INSTALLATION OF CUSHION BARRIER
AT LUNALILO FRWY - VINEYARD (OFF-RAMP)
& STA. 83+00
SAFETY IMPROVEMENTS ALONG
INTERSTATE H-1
KALIHI ST. TO PALI HIGHWAY
Proj. No. I-HI-1(112):19 Date: April, 1973

STATE OF HAWAII
DEPARTMENT OF TRANSPORTATION
HIGHWAYS DIVISION
INSTALLATION OF CUSHION BARRIER
AT LUNALILO FRWY. & RAMP "5"
@ Sta. 103+50
SAFETY IMPROVEMENTS ALONG
INTERSTATE H-1
KALIHI ST. TO PALI HIGHWAY
Proj. No. I-H-1(112)19 DATE: April, 1973

C. O. 45

SAFETY IMPROVEMENTS ALONG
INTERSTATE H-1
KALIHI ST. TO PALI HIGHWAY

SHEET No. 40 OF 110 SHEETS

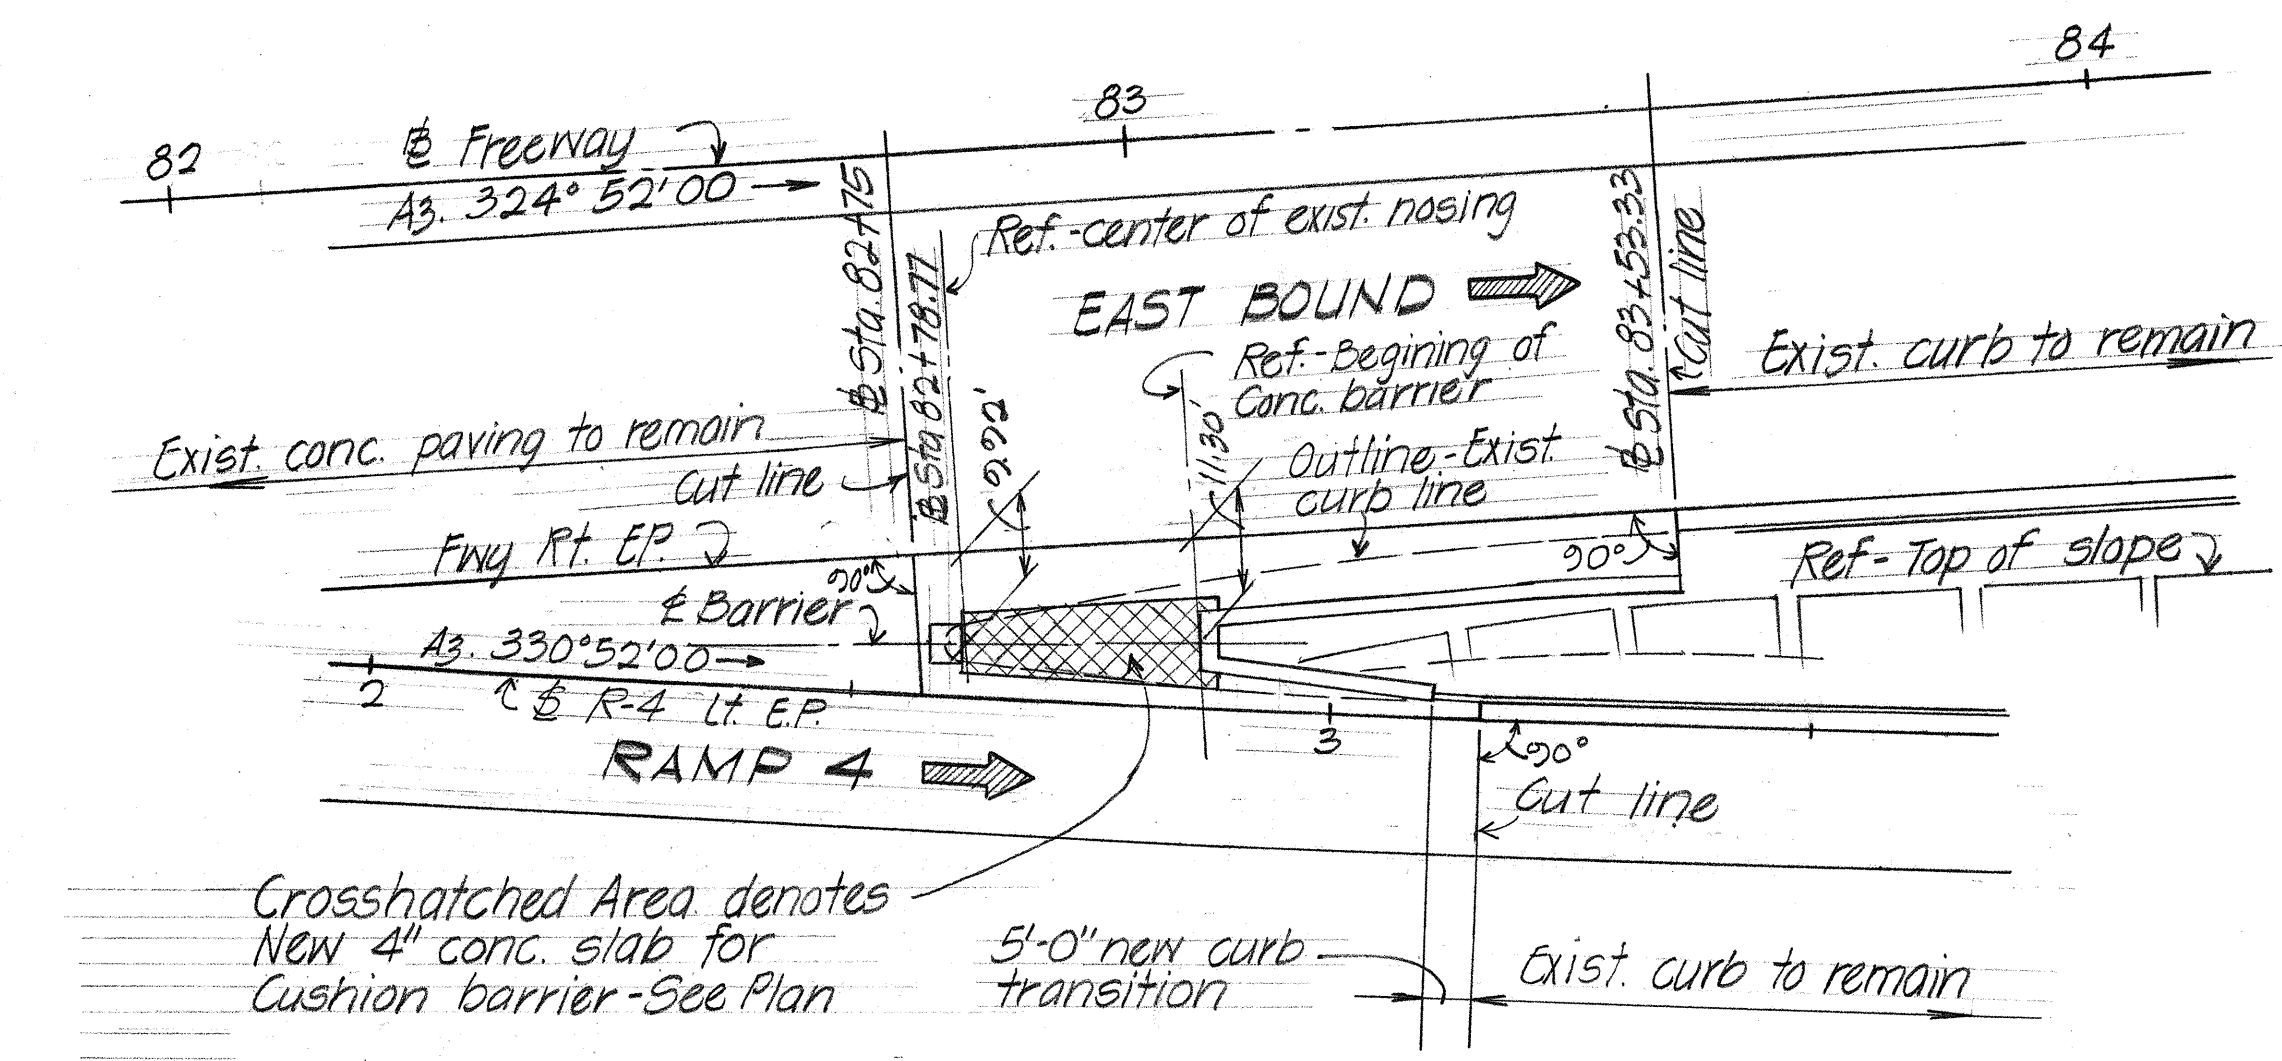
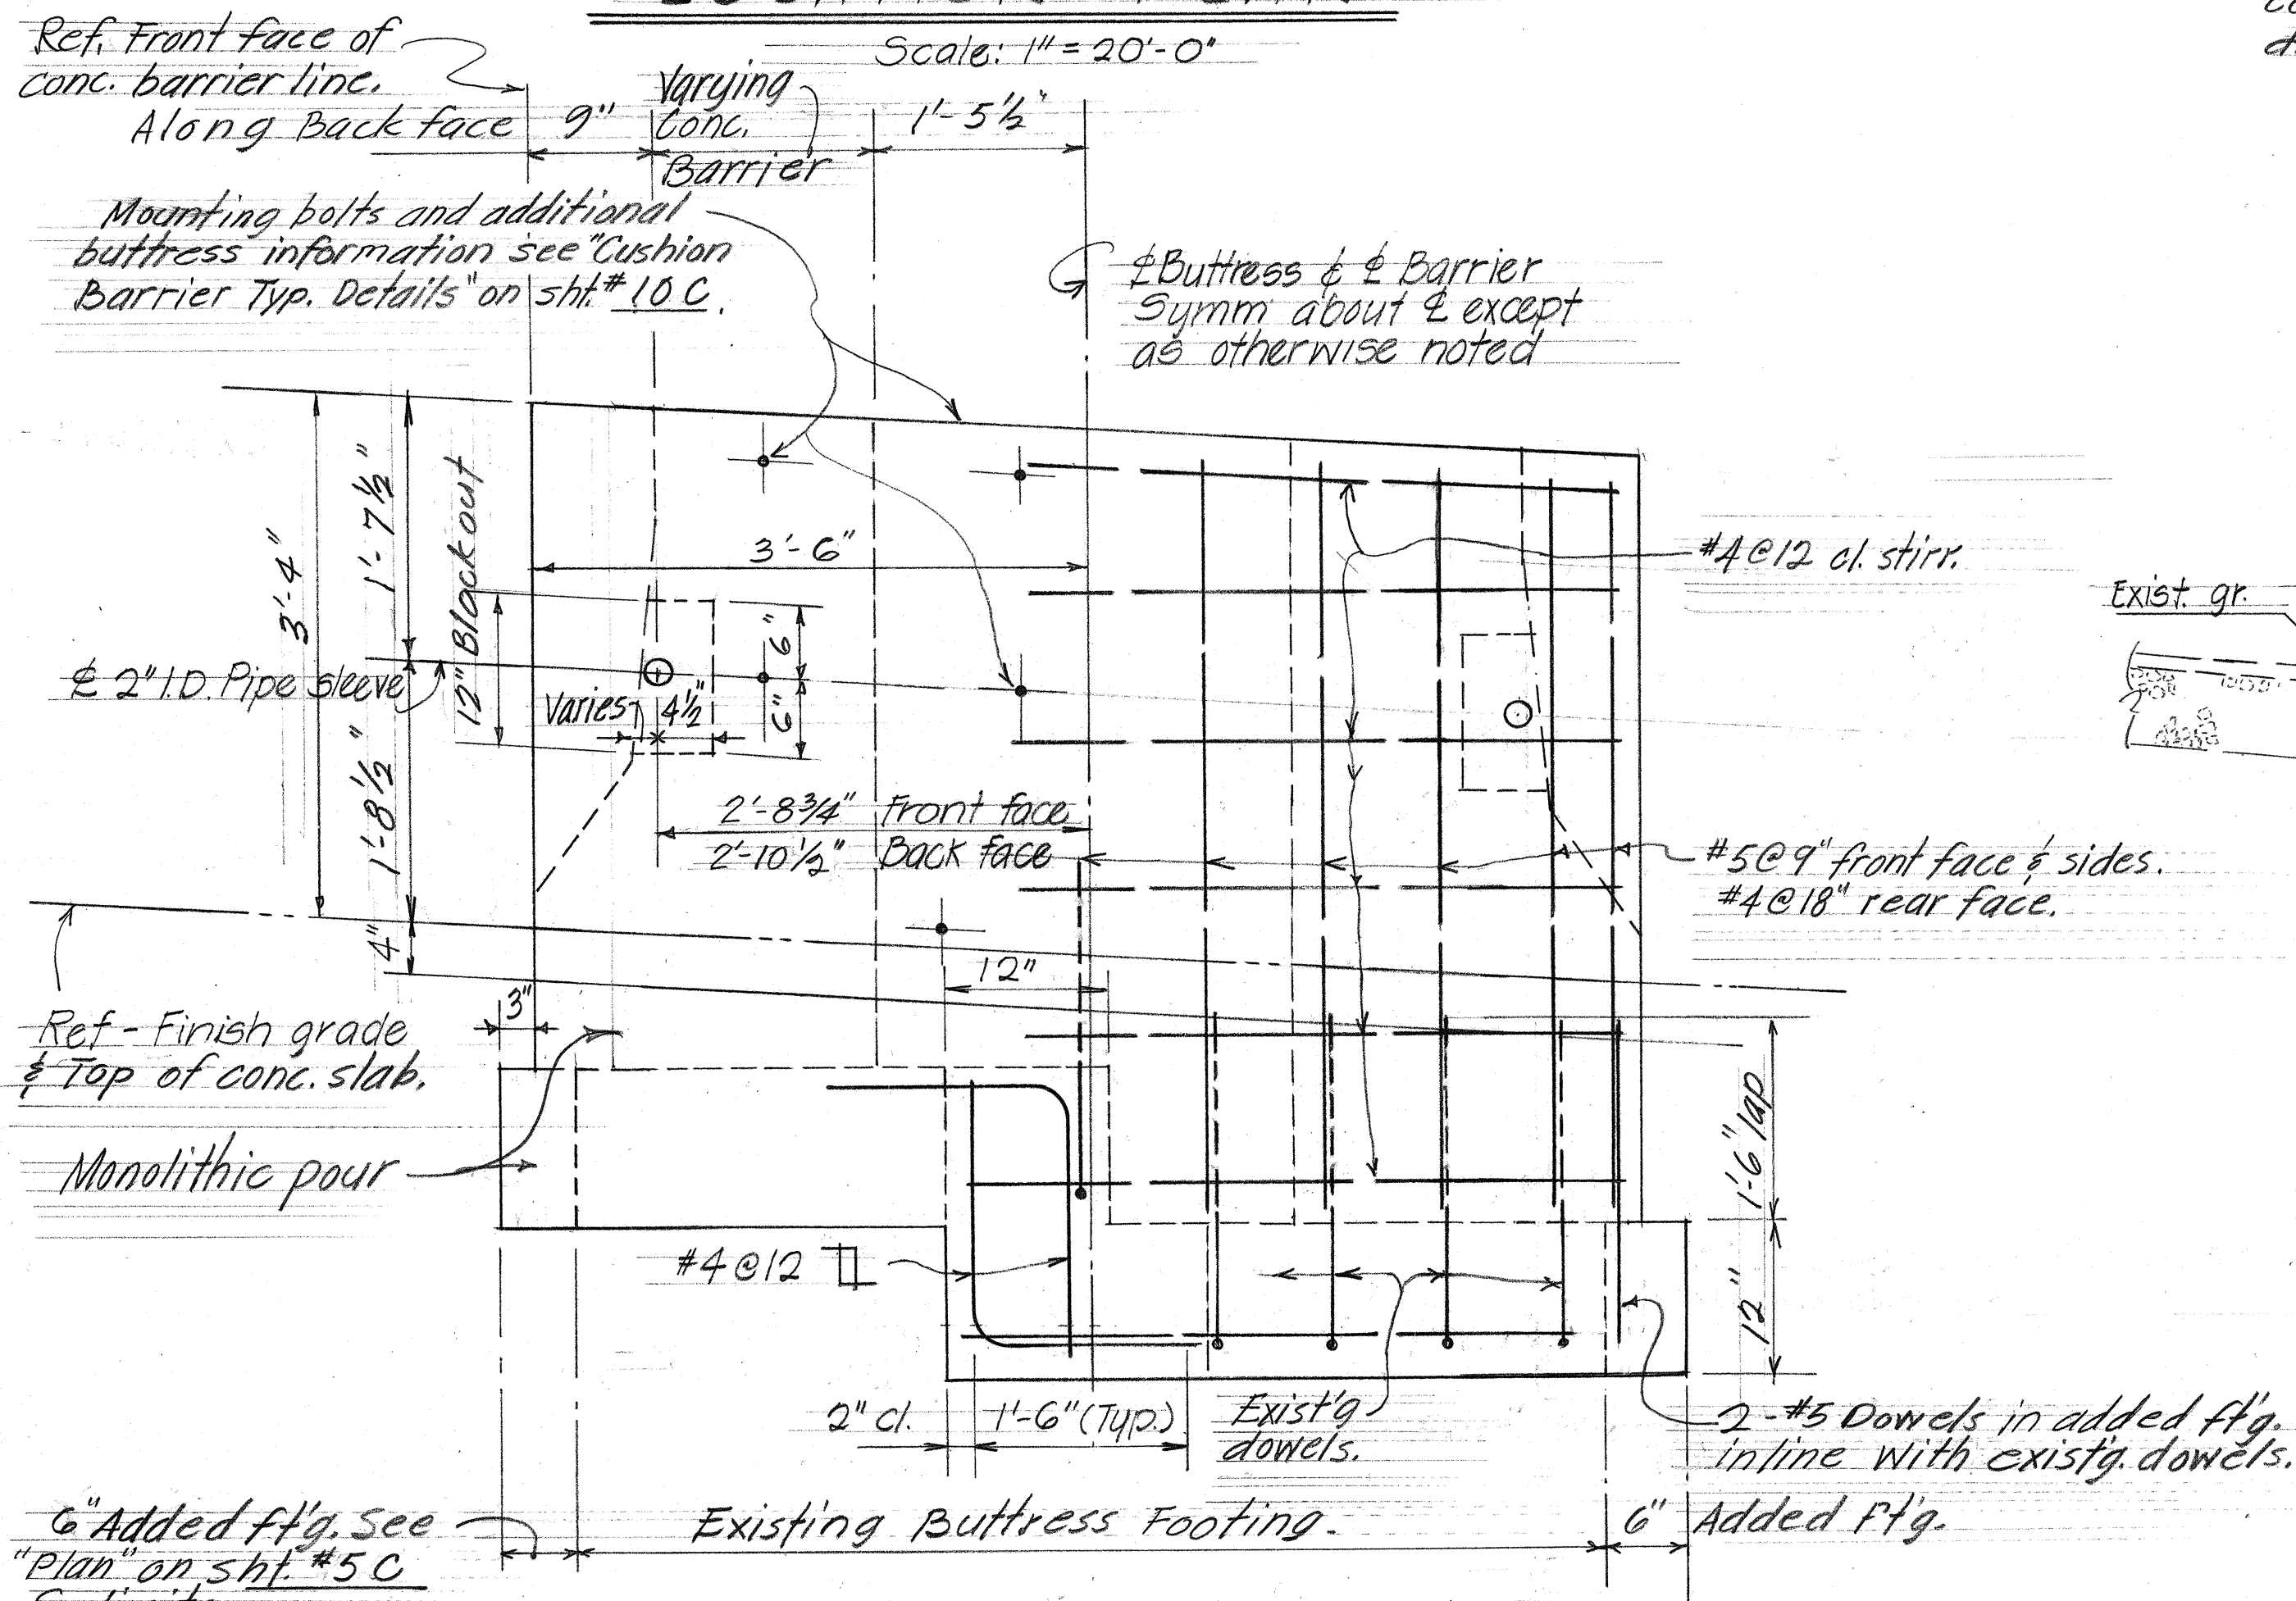
11-27-'74 Buttness width increased from 6' to 7'-0" due to modification of cushion barrier system. Adjoining concrete barrier revised to match revised buttness.
